CERTIFICATE OF APPROPRIATENESS

RE: Application Number 21-7584; 1315 Broadway, Broadway Historic District

Rehabilitate building, including storefront replacement, window repair, and rebuilding of rear fire escape

1315 Broadway Concept Design September 27, 2021

FRONT ELEVATION

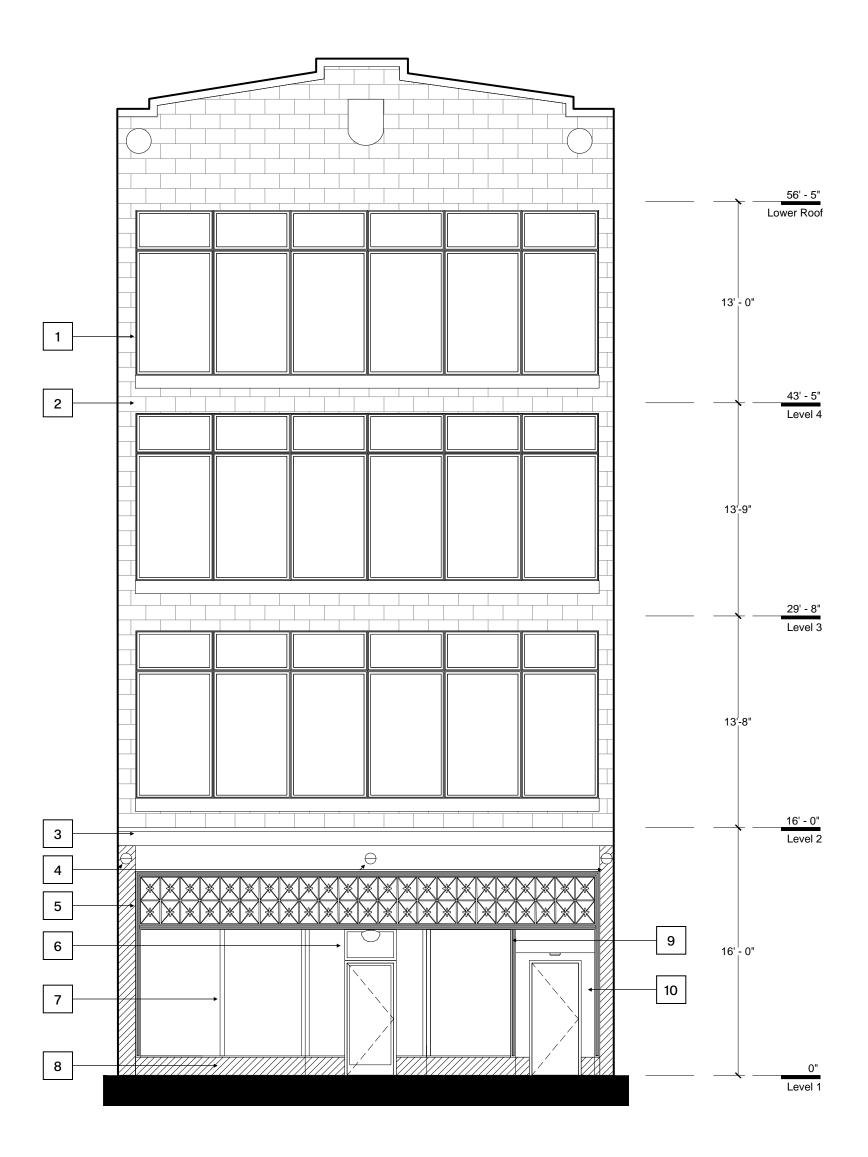
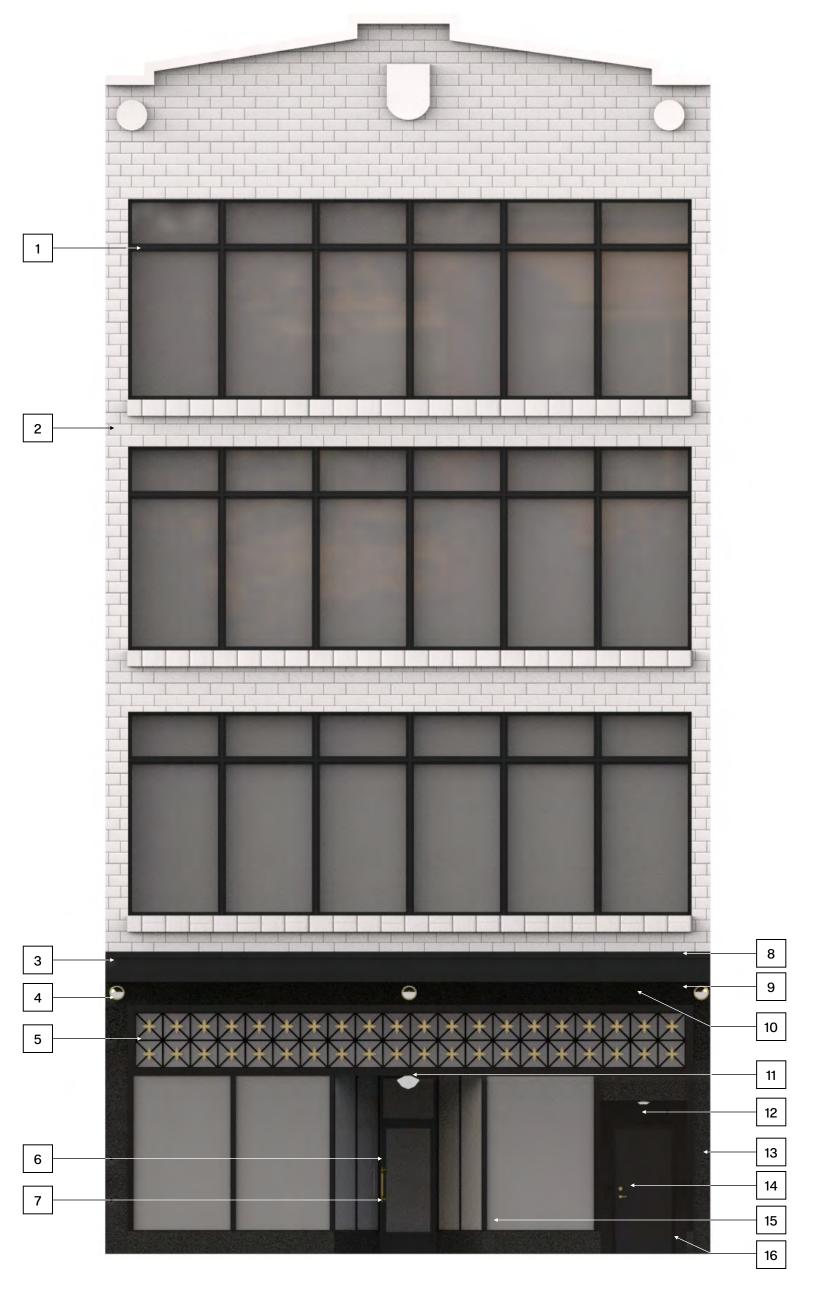
- Retain existing front entrance door surround (transom and threshold); install a wood door with full glass panel.
- Retain existing alcove pendant light. If the existing fixture is beyond repair, a similar fixture and finish will be selected and submitted for staff review.
- Catalog cuts for the front elevation's side alcove flush door and the rear elevation's hollow metal door (both black) will be submitted for staff review.
- Elevation and section confirming how the metal will be installed, as well as the catalog cut of the selected metal confirming the type, durability and design will be submitted for staff review.
- The catalog cut for the up-down lights within the awning (including placement identification) will be submitted for staff review.
